BLUE BIRD

GM 8.1 Knock Sensor

MODELS AFFECTED: 2009 & 2010 Propane Visions

S10RN

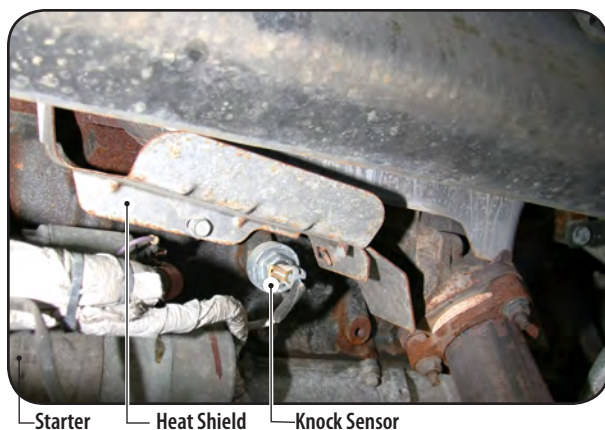
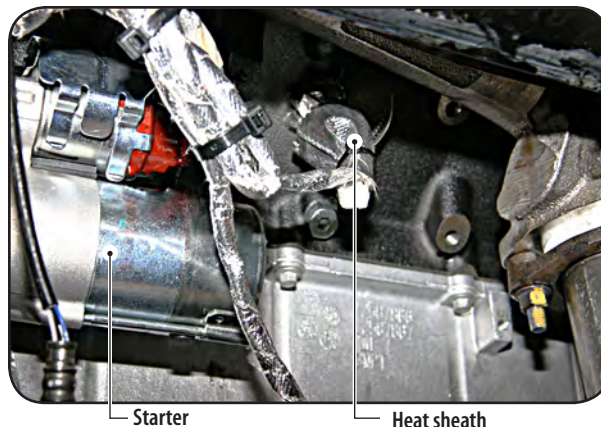
The GM knock sensor may fail due to a heat shield having been eliminated on some GM 8.1 engines.

Inspect knock sensor and install a heat sheath if neither heat shield nor heat sheath is not present.

- 4.1 Disconnect sensor harness from knock sensor.
- 4.2 Slide heat sheath onto sensor harness and place clamp over sensor on engine.
- 4.3 Reconnect sensor harness to sensor, slide heat sheath over knock sensor and electrical connection all the way to the engine block.
- 4.4 Position clamp over heat sheath between sensor body and sensor mounting boss. Do not clamp on top of sensor body.
- 4.5 Tighten clamp. Do not over-tighten clamp as damage to knock sensor may occur.
